2. AMENDMENT/MODIFICATION NO. 0001	3. EFFECTIVE DATE 05/14/2015	4. REQUISITION/PURCHASE REQ. NO.	PROJECT NO. (If applicable)
---------------------------------------	---------------------------------	----------------------------------	-----------------------------

DESIGN-BID-BUILD SPECIAL PROJECT RM159-06, B260, NUCLEAR EQUIPMENT MAINTENANCE AND INSPECTION FACILITY, NAVAL SUPPORT ACTIVITY, NORFOLK NAVAL SHIPYARD, PORTSMOUTH, VA

Continuation Sheet

1. The following questions below are answered with the revised Sheet A-602 labeled BLDG260-1146716-A-602r see below.

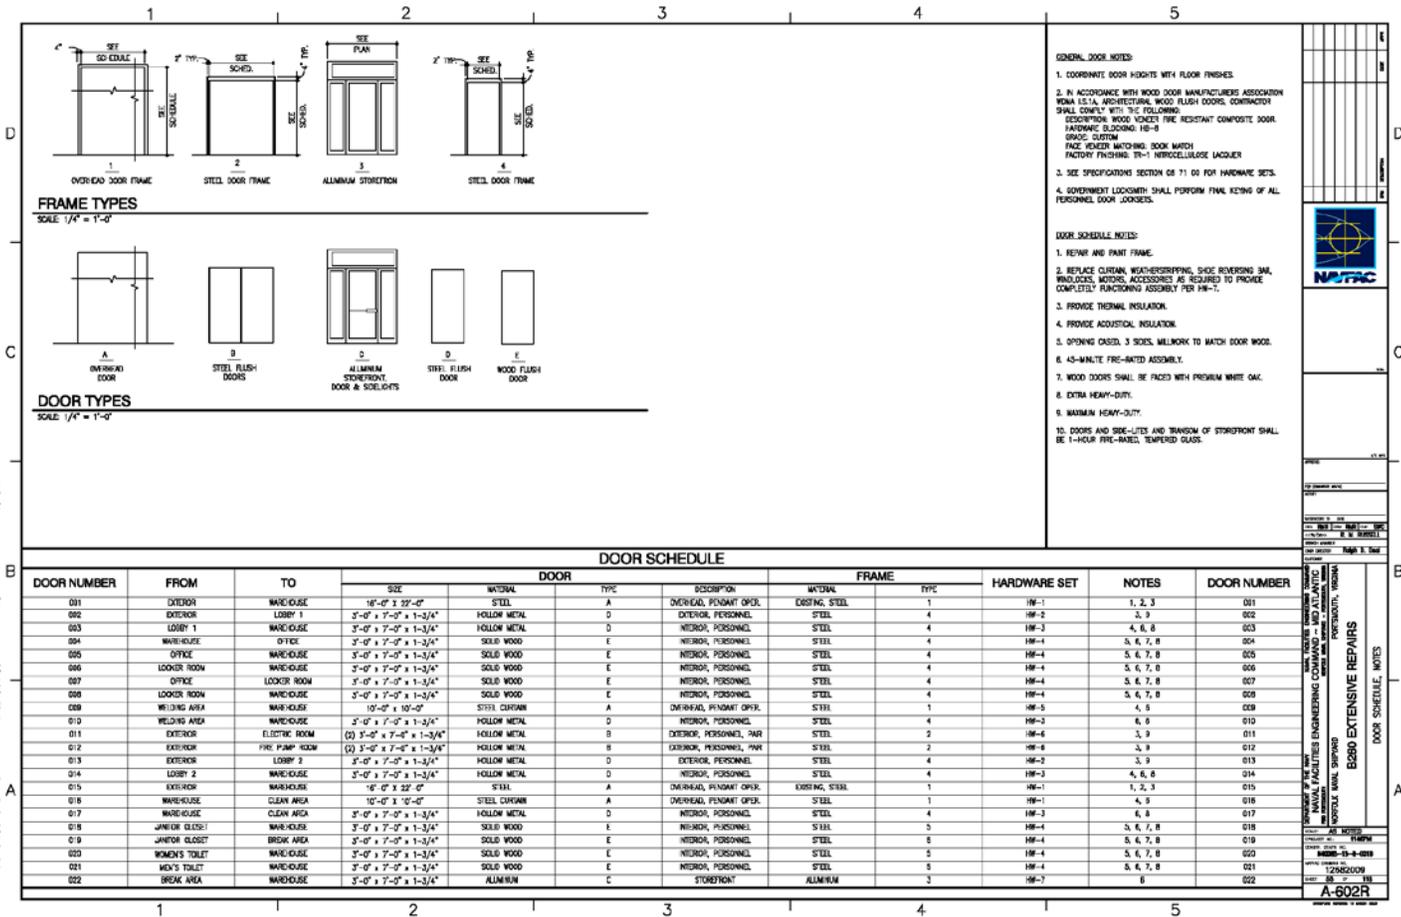
- The door schedule list 8 openings with a type 5 frame but no type frame is show in the "Frame Types" section above. Please clarify.
- The door schedule indicates that there are no frame types 1. I believe this is a mistake. Please verify that there are no frame type 1 required.

- The door schedule indicates that there are 2 frame types X. No frame type X is shown in the Frame Types located above the door schedule. Please Clarify.

- The entire Frame Type portion of the Door Schedule is inaccurate. There are pairs of 3070 doors shown in 3070 openings and single 3070 doors shown in 3060 openings. Please review the accuracy of the entire door schedule, make the necessary corrections and reissue the entire door schedule to help avoid any confusion.

- The door schedule indicates that door number 015 is required to have a 45 minute fire rating. This is an existing exterior door which appears to be an exact match to door 001 which has different requirements. I do not believe this is correct. Please verify that door 015 is required to have a 45 minute fire rating.

- The door schedule indicates that door number 001 is required to be repaired to a new condition or replaced. Insufficient information has been provided to allow for this item of work to be priced out in advance for this firm fixed price contract. Please provide information necessary to determine the cost of repairing or replacing the existing door.

- Base Note 2 (Located in the center of the page) references "Wall Section E, Detail A5/A-301. It appears that the referenced detail is not contained on this drawing. Please either provide the requested detail or tell me where I can find this information.
